# Duquesne Light

2NRC-4-150

SUBJECT: Beaver Valley Power Station - Unit No. 2  
Docket No. 50-412  
PSB Electrical Outstanding Issues

This letter forwards responses to the issues listed below which were provided by PSB in a draft SER on June 8, 1984. FSAR Changes described in these responses are intended to be incorporated upon acceptance by PSB. The following items are attached:

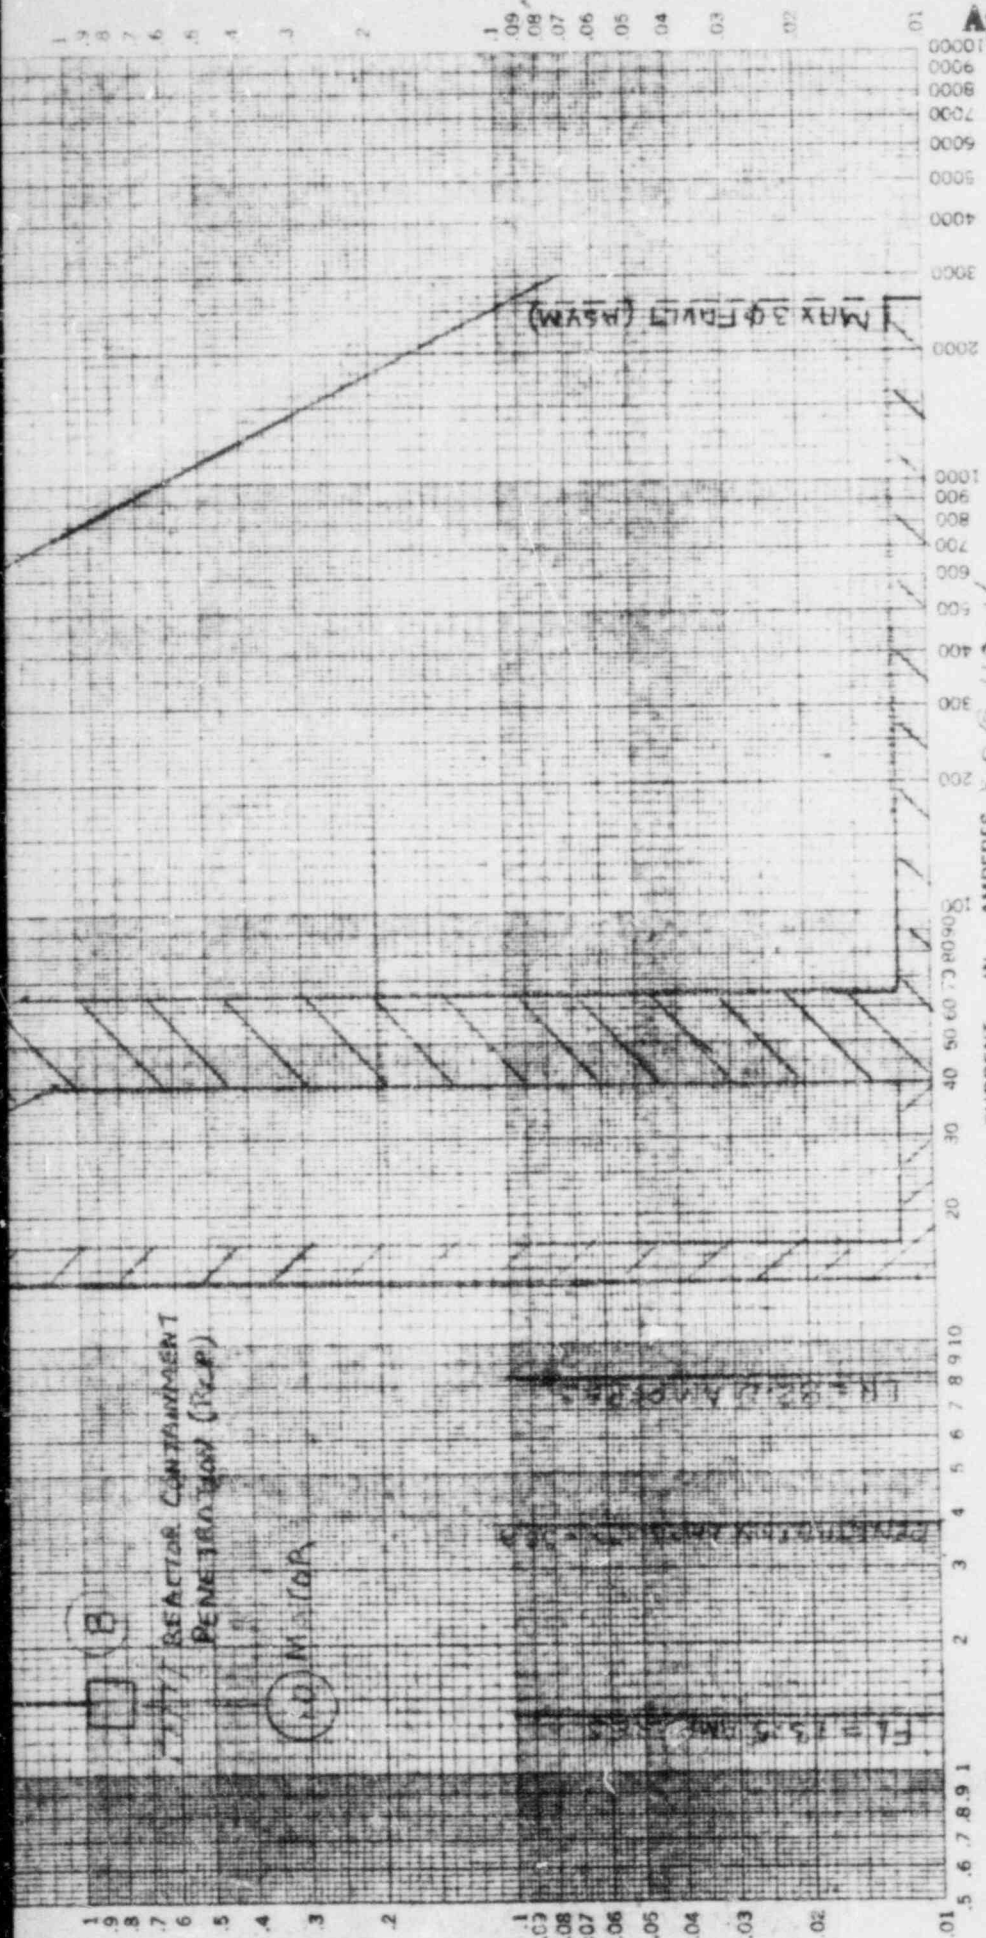
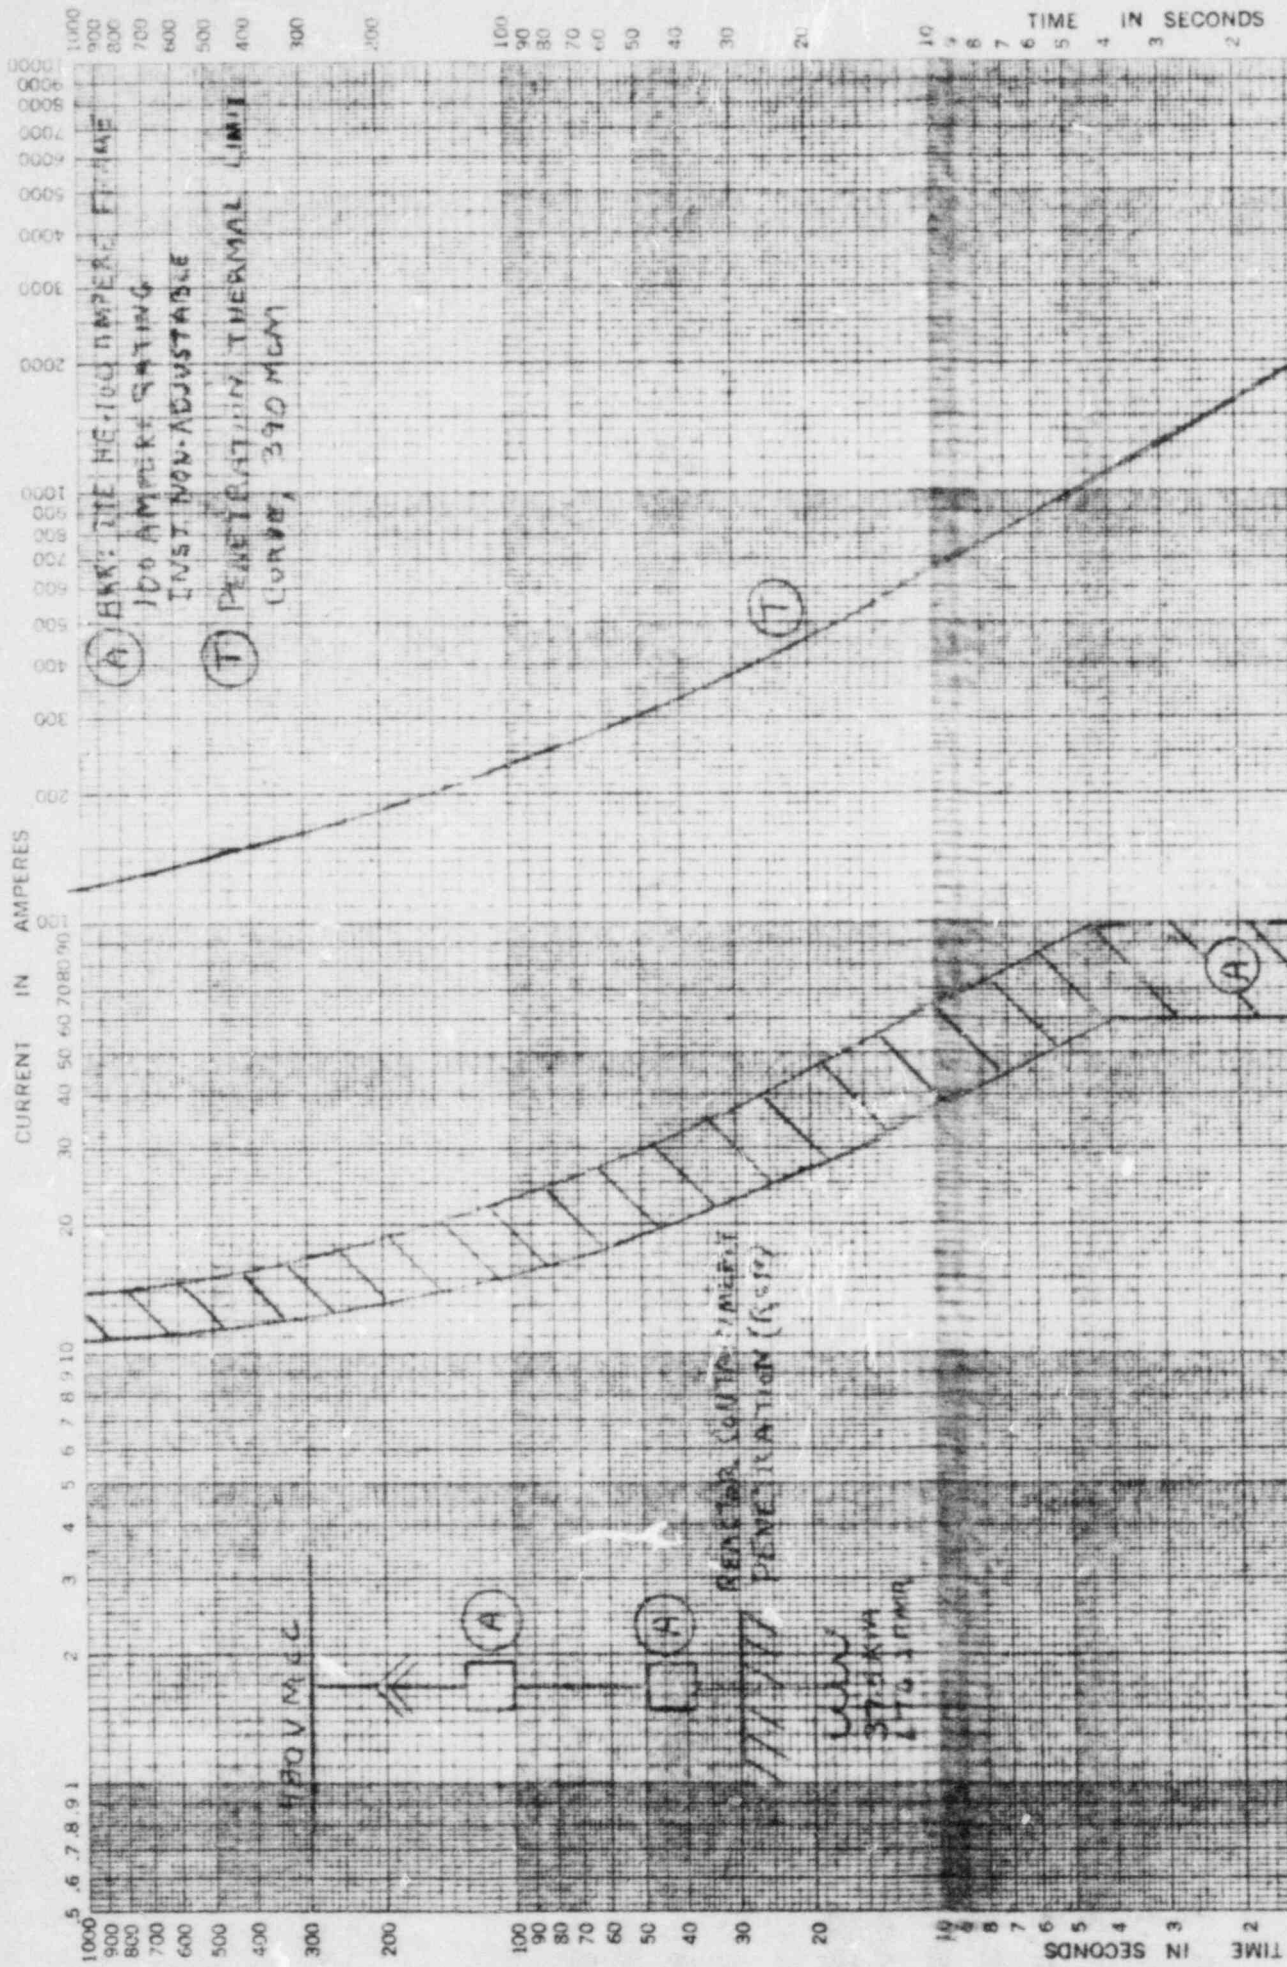
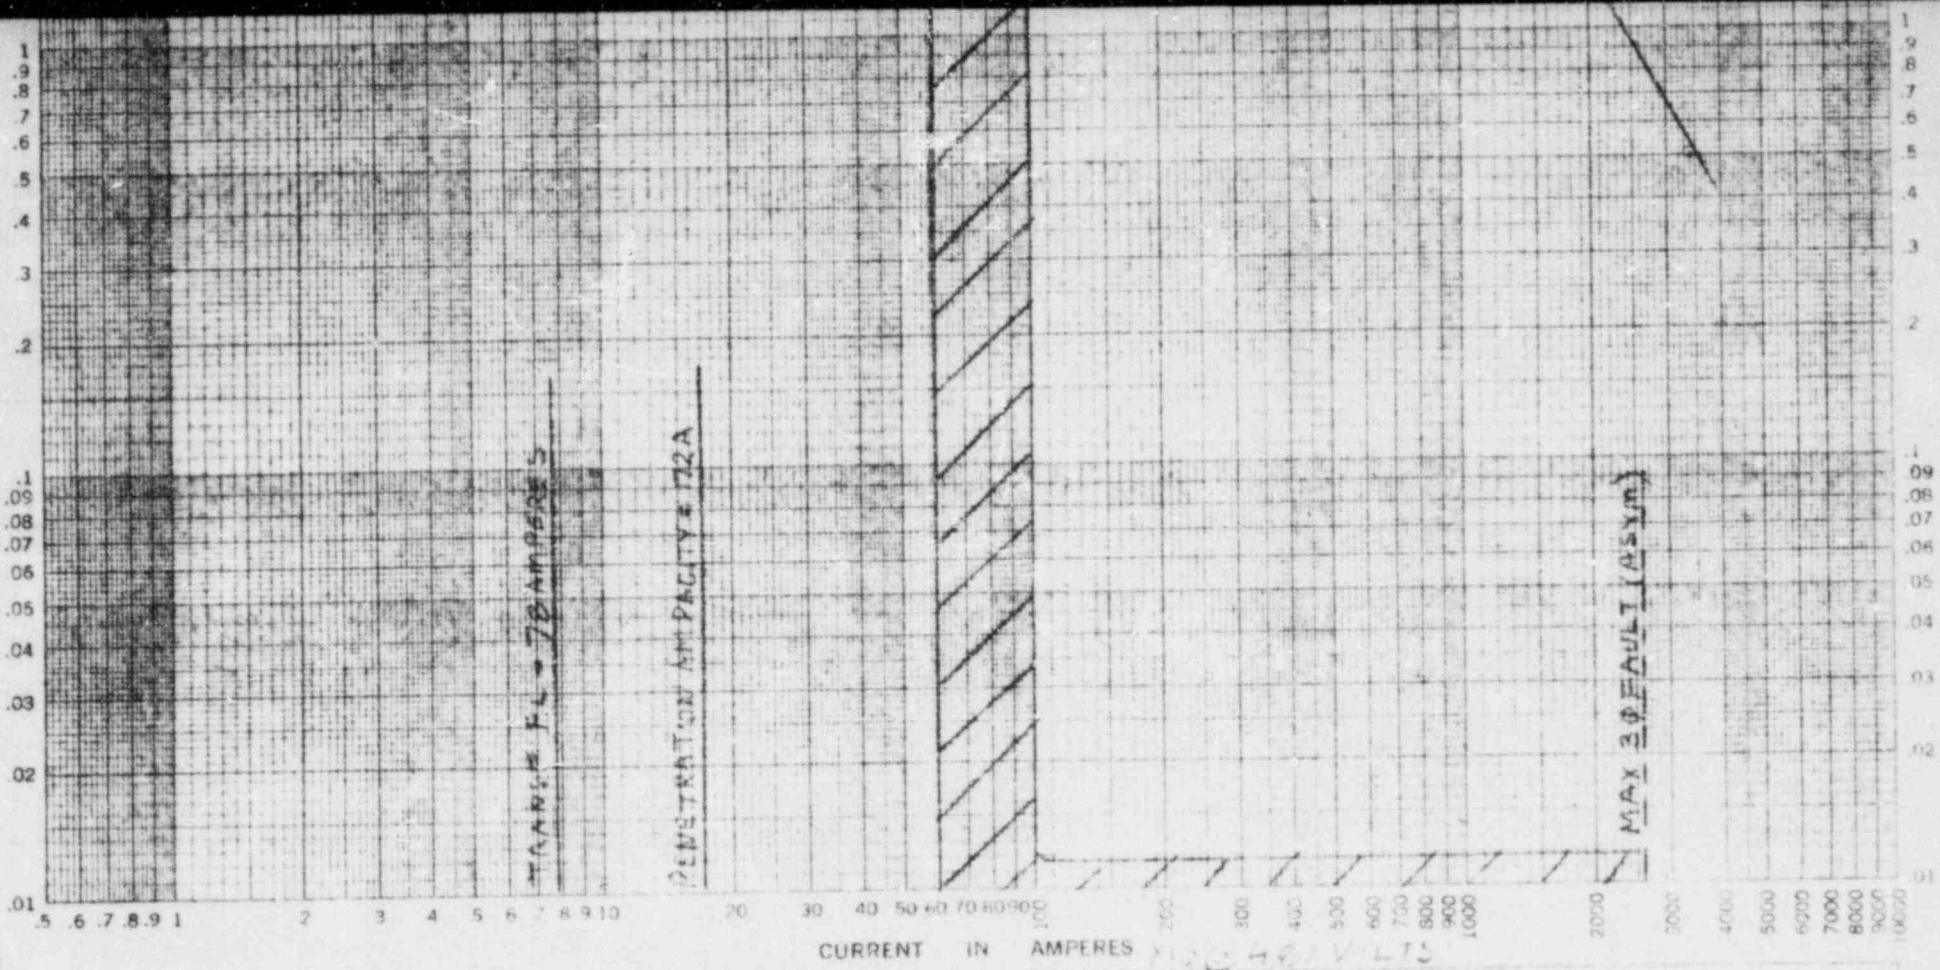
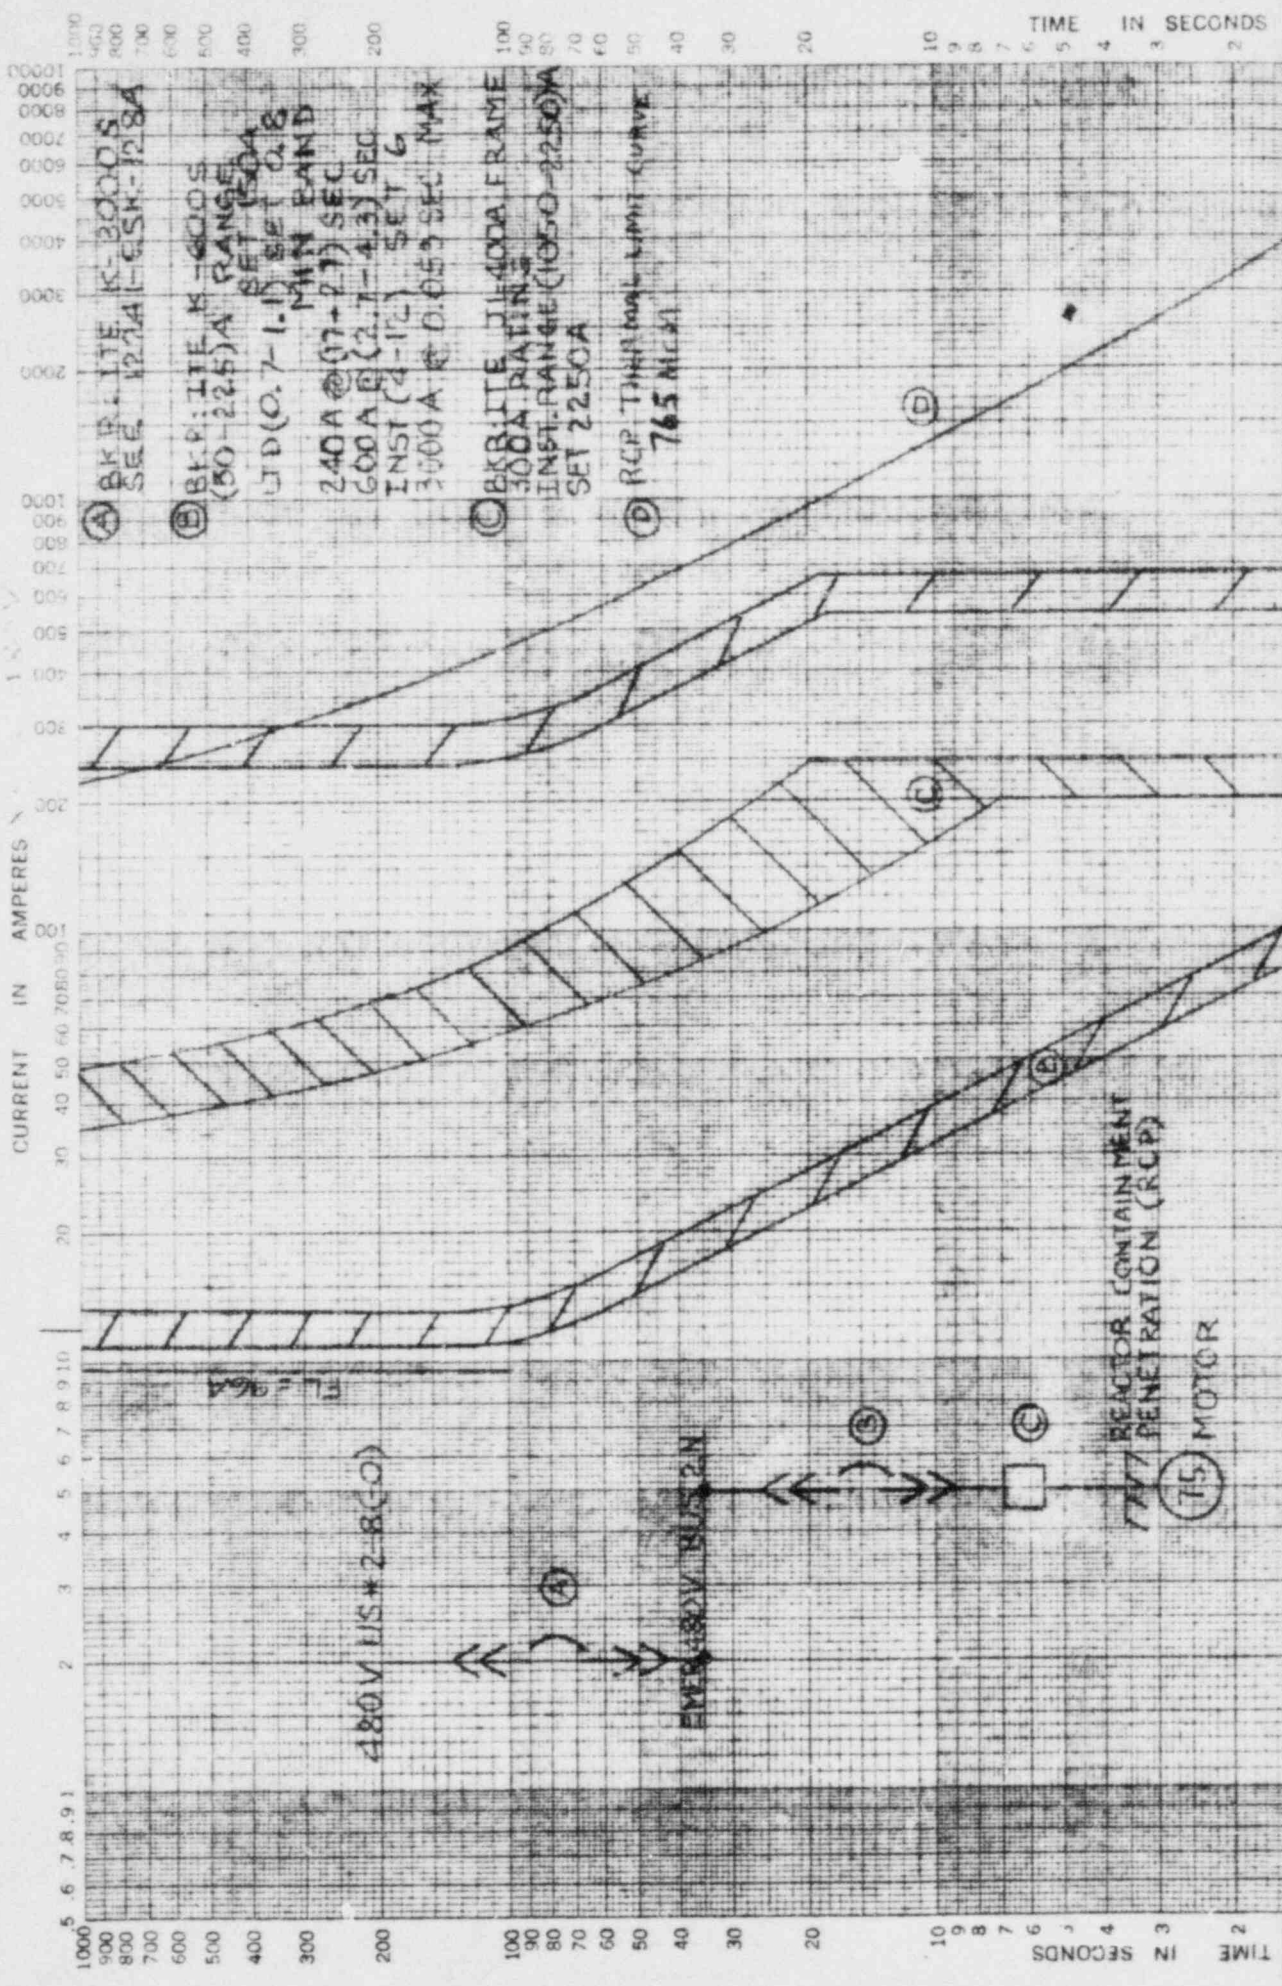
Section 8.3.1.2.1 of the FSAR indicates that primary and backup containment electrical penetration protection is provided only where the available fault-current exceeds the current-carrying capabilities of penetration conductors. This design for containment electrical penetration does not meet the guidelines of position 1 of Regulatory Guide 1.63. Position 1 requires primary and backup protection where maximum available fault-current exceeds the current-carrying capability of the penetration versus capability of the conductors.

By Amendment 3 to the FSAR, the applicant indicated that the Beaver Valley design provides primary and backup protection as required by RG 1.63 and that the following additional information would be provided by March 1984:

- a. fault-current versus time curve for each representative type cable conductor which penetrates primary containment
- b. test report which verify the capability of penetration to withstand the total range of time versus fault current for worst case environmental conditions

Attached is the following additional information as requested:

- a. fault-current versus time curves for each representative type cable conductor which penetrates primary containment
- b. test report excerpts which verify the capability of penetrations to withstand the total range of time versus fault current for worst case environmental conditions
